Model: V-C2	Date: 15-Nov-07	No.: RD014001o
-------------	-----------------	----------------

Subject: Firmware Release Note: Engine		Prepared by: C. Shimaji	
From: 1st Tech Service Sect., MFP/Printer Tech Service Dept			
Classification:	<input type="checkbox"/> Troubleshooting	<input type="checkbox"/> Part information	<input type="checkbox"/> Action required
	<input type="checkbox"/> Mechanical	<input type="checkbox"/> Electrical	<input type="checkbox"/> Service manual revision
	<input type="checkbox"/> Paper path	<input type="checkbox"/> Transmit/receive	<input type="checkbox"/> Retrofit information
	<input checked="" type="checkbox"/> Other ()

This RTB has been issued to announce the firmware release information for the **Engine**.

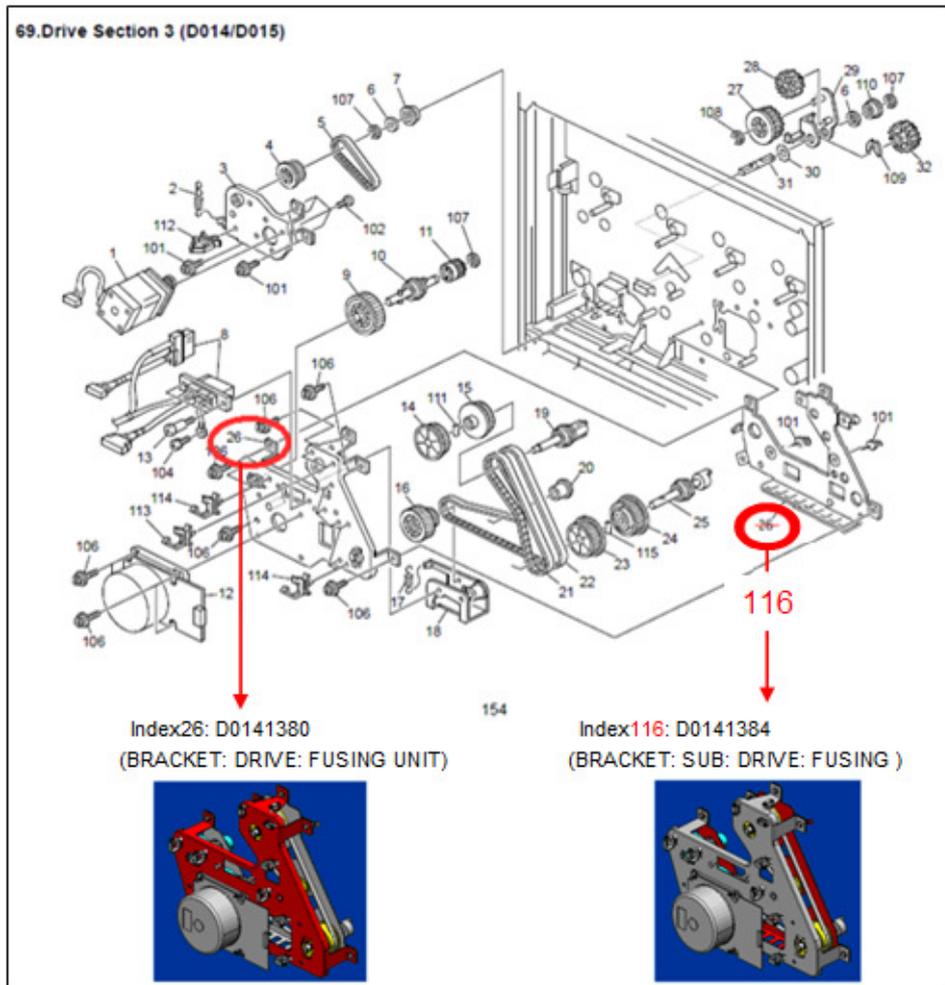
Change/Reason: The illustration was corrected as shown below.
